Project	IEEE 802.16 Broadband Wireless Access Working Group < http://ieee802.org/16 >	
Title	Action items from session #43 and new introductory material for the Working Draft (80216h-06 015)	
Date Submitted	2006-07-20	
Source(s)	Paul Piggin NextWave Broadband Inc. 12670 High Bluff Drive San Diego CA 92130	Voice: 858 480 3100 Fax: 858 480 3105 ppiggin [at] nextwave.com
Re:	Recirculation of Working Group Review of Working Document 80216h-06 015	
Abstract	This document contains 1) Suggested remedies to action items from session #43 from Working Group Review 2) New material pertaining to the introductory sections of the Working Draft.	
Purpose		
Notice	This document has been prepared to assist IEEE 802.16. It is offered as a basis for discussion and is not binding on the contributing individual(s) or organization(s). The material in this document is subject to change in form and content after further study. The contributor(s) reserve(s) the right to add, amend or withdraw material contained herein.

Action items from session #43 and new introductory material for the Working Draft (80216h-06_015)

Figure 1 Flowchart algorithm for specific spectrum users.

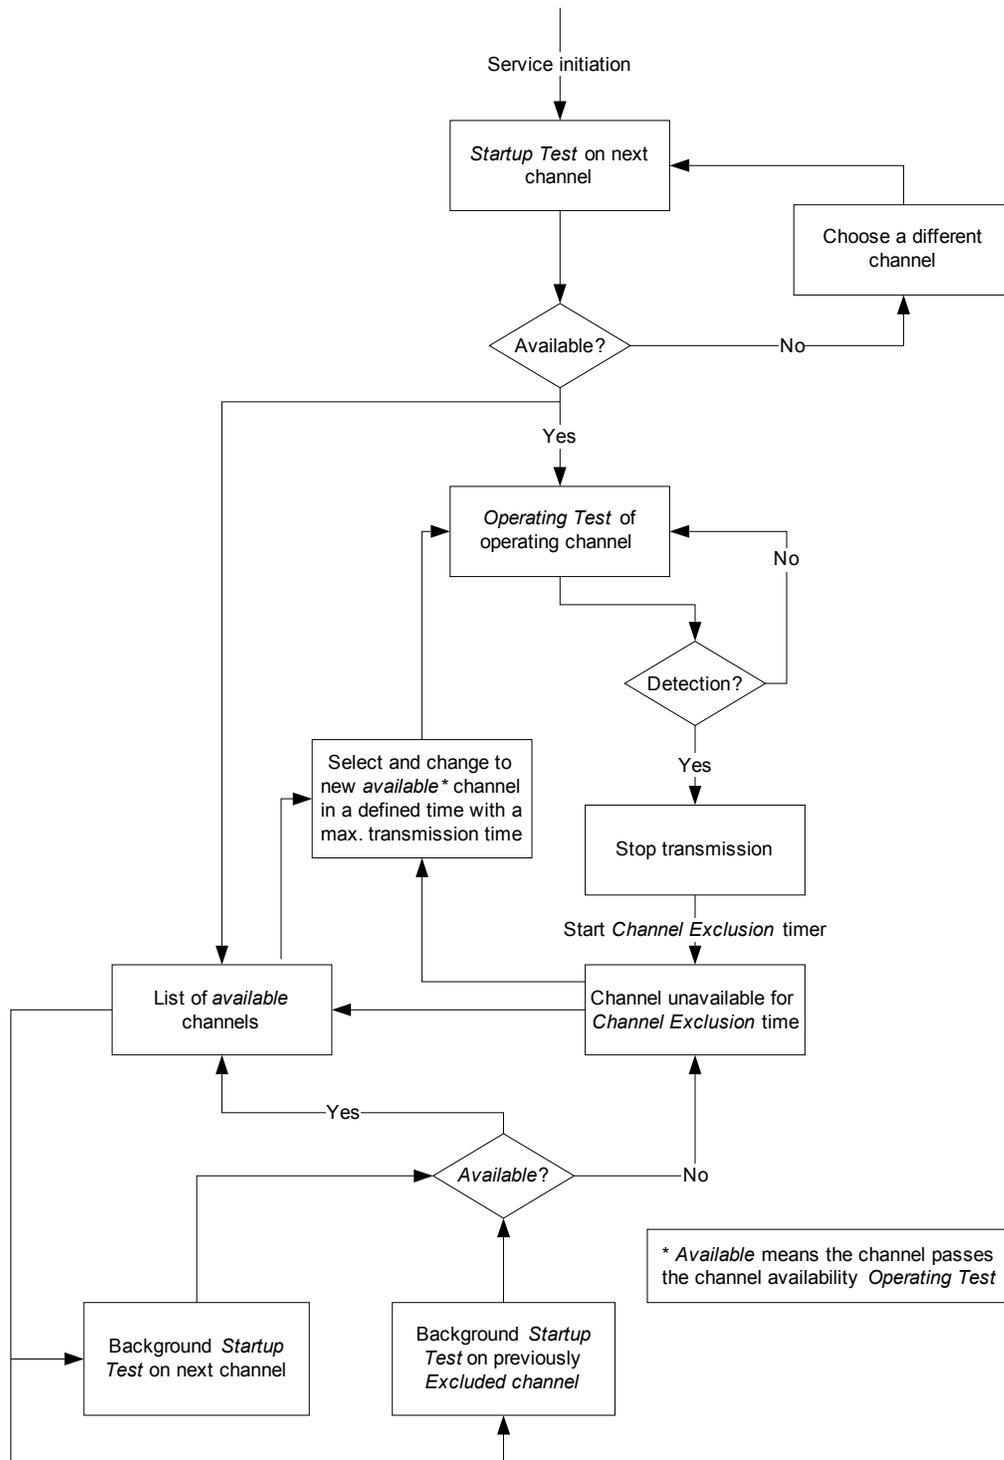
- 1) Suggested remedies to action items from session #43's Working Group Review, namely
Comment 26 of [2] – Correction of document figures.

Figure 1 provides the replacement figure for the flowchart algorithm for specific spectrum users. This is Figure h1 in section 6.3.15 of [1].

Figure 2 Representation of extended channel numbering structure.

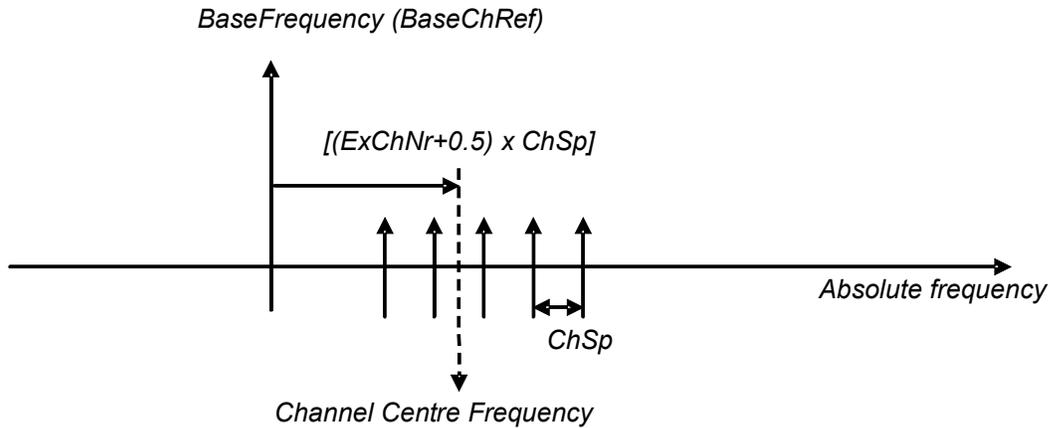
Figure 2 provides a replacement figure for the extended channel numbering structure. This is figure h2 in section 6.4.1.2 of [1].

Figure 3 Representation of co-existence schemes addressed by Task Group h.

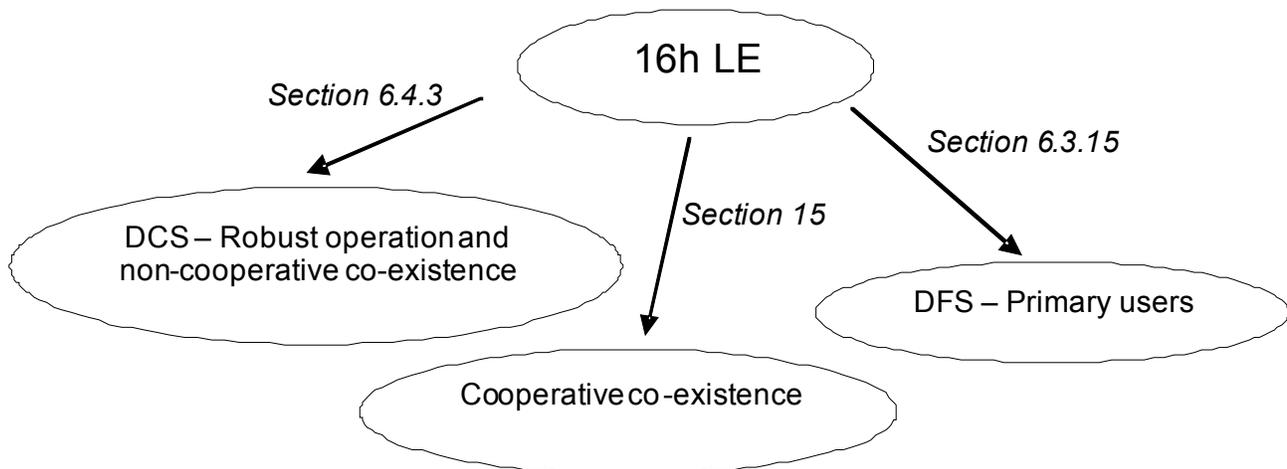
This section details amendments to the working document [1] addressing unresolved comments in [2]. The specific areas to be considered are given below:

Statement on how robust operation in LE bands can compliment that given in section 15 of the working document.

Figure xyz Link level representation of DCS operation: (a) interference and remedial action at the BS, (b) interference and remedial action at the MS/SS.

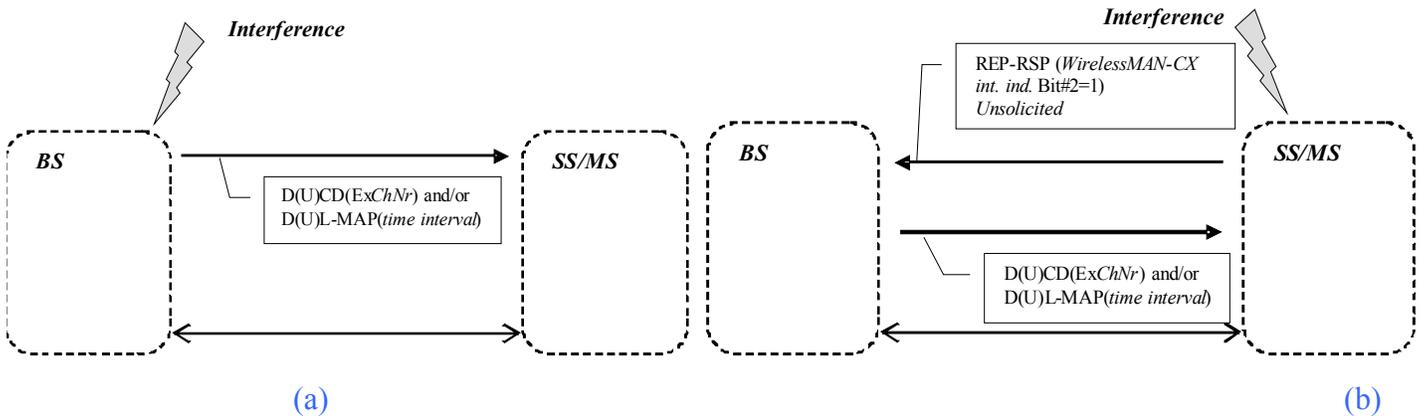
Add a new section 6.4.3

[A general example of a DCS solution is provided in figure xyz in which interference detection provides agility in frequency and time to reduce the affects of the incident interference. Figure h1 \(section 6.3.15.1\), although for specific spectrum users, provides a further example of how DCS can be used to provide resource management.](#)
